JUICE AO Clarifications Meeting – Technical Questions & Answers

C. Erd
ESTEC
13/07/2012

Figure 3 S/C Coordinate system (TBC).

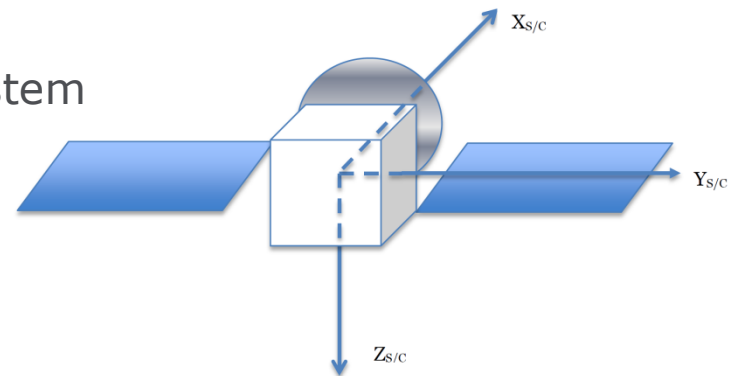
Q: Spacecraft accommodation: Figure 3 of the EID-A document corresponds to one of the three spacecraft architectures studied by industries; others are different. Does Figure 3 indicate a favoured configuration for the spacecraft architecture ?

1. This figure does not correspond to a specific s/c configuration; it is only schematic.
2. The figure caption indicates that the information is TBC
3. There is no favoured s/c configuration
4. Its purpose is to describe a coordinate system
